MIL-F-70823A (AR)
AMENDMENT 1
18 September 1996

MILITARY SPECIFICATION

FUZE, ELECTRONIC TIME, M762
LOADING, ASSEMBLING AND PACKING
AND
FUZE, ELECTRONIC TIME, M767 LESS BOOSTER

TABLE I-A M762/M767 less booster first article cold temperature sequential operational and safety tests

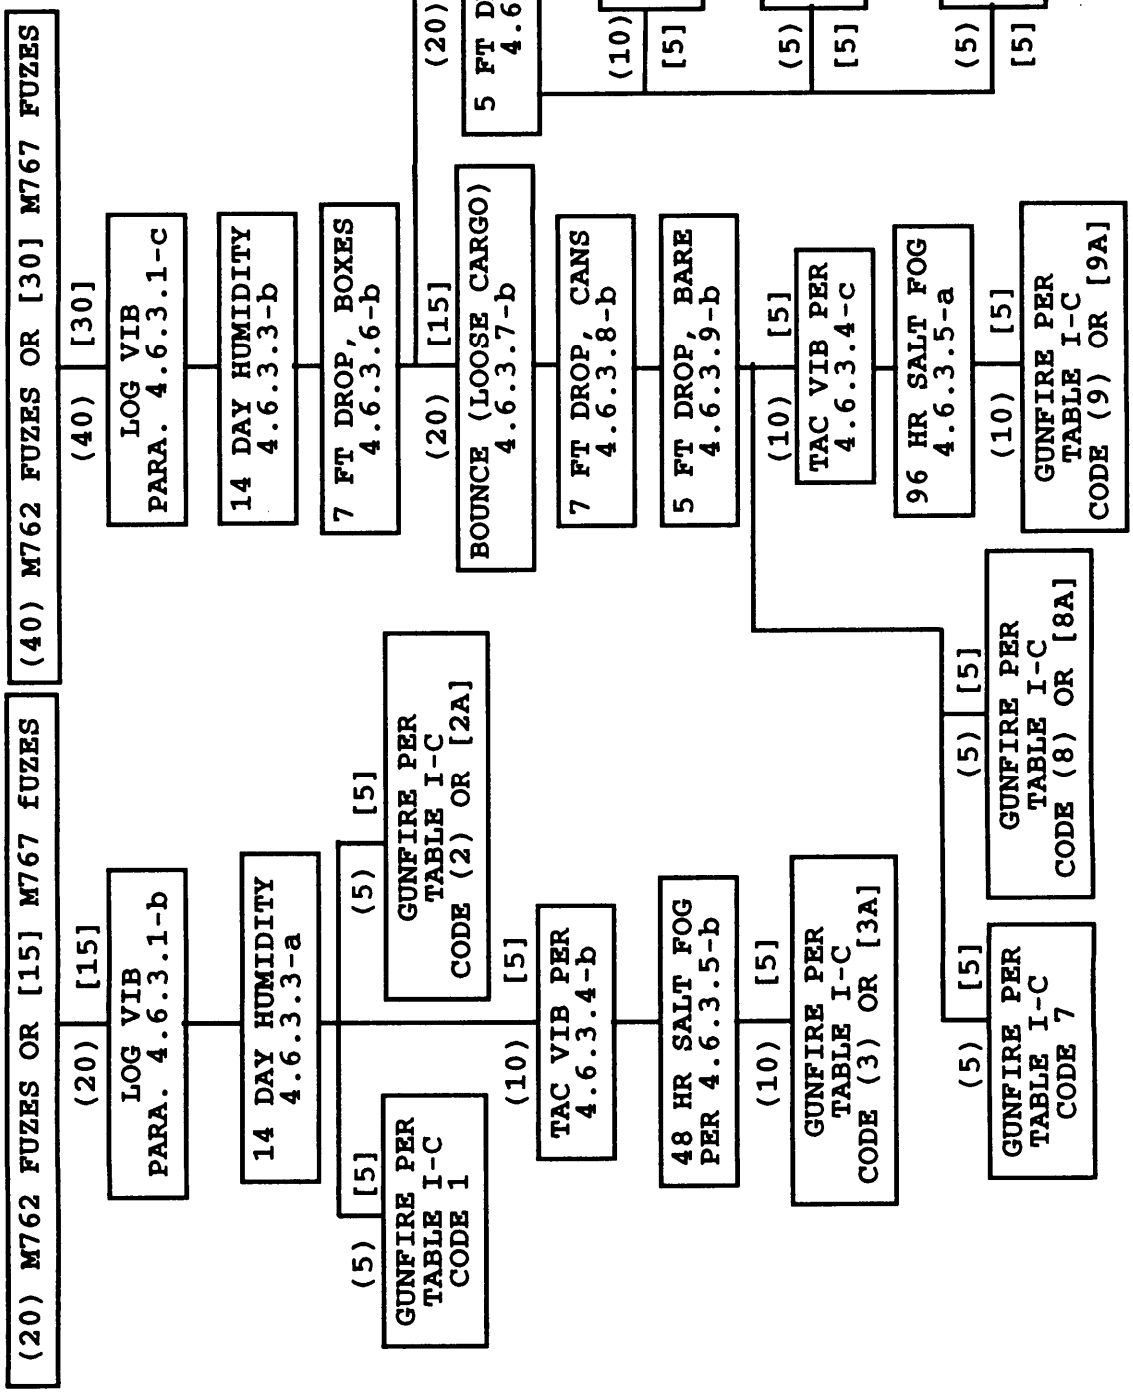
Delete TABLE I-A in its entirety and substitute new TABLE I-A included.

Note: The numbers enclosed by ( ) brackets shall apply to M762 fuze only.
The numbers enclosed by [ ] brackets shall apply to M767 fuze less booster only.

TABLE I-B M762/M767 less booster first article hot temperature sequential operational and safety tests

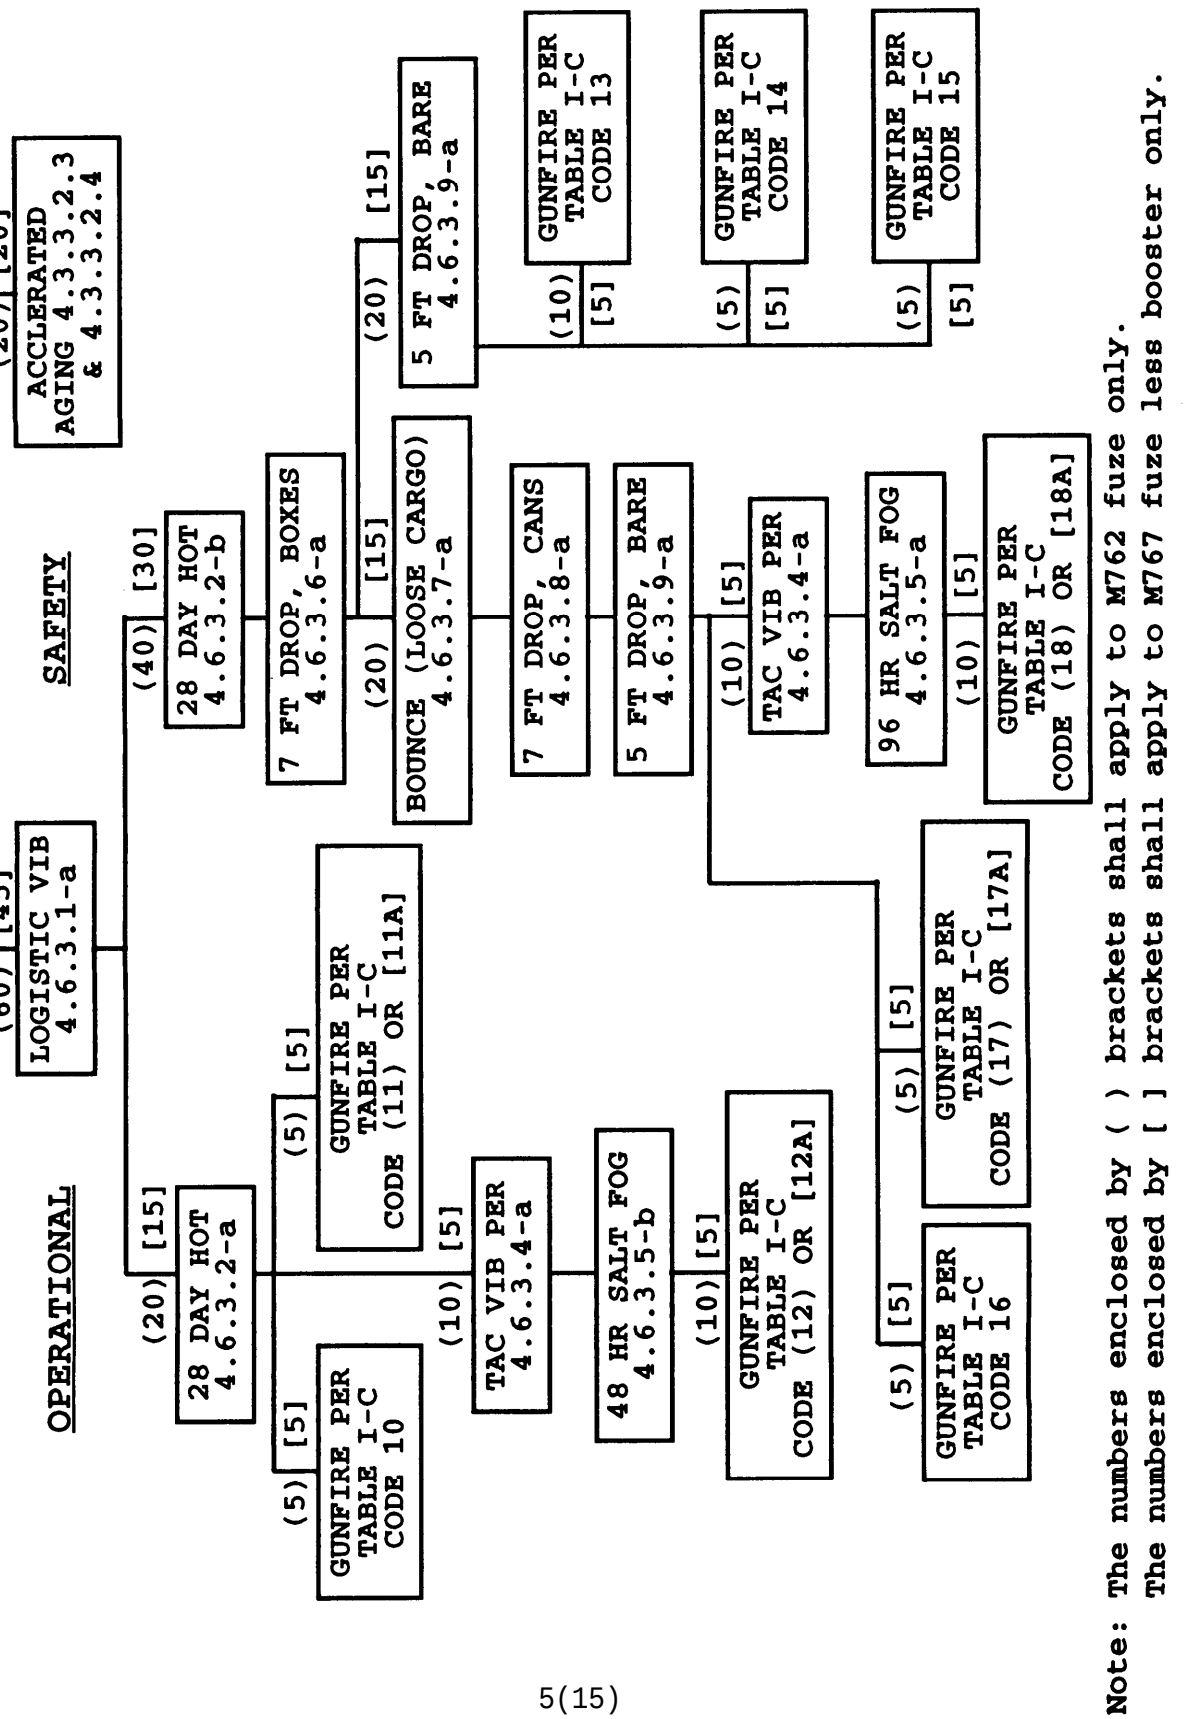
Delete TABLE I-B in its entirety and substitute new TABLE I-B included.

Note: The numbers enclosed by ( ) brackets shall apply to M762 fuze only.
The numbers enclosed by [ ] brackets shall apply to M767 fuze less booster only.
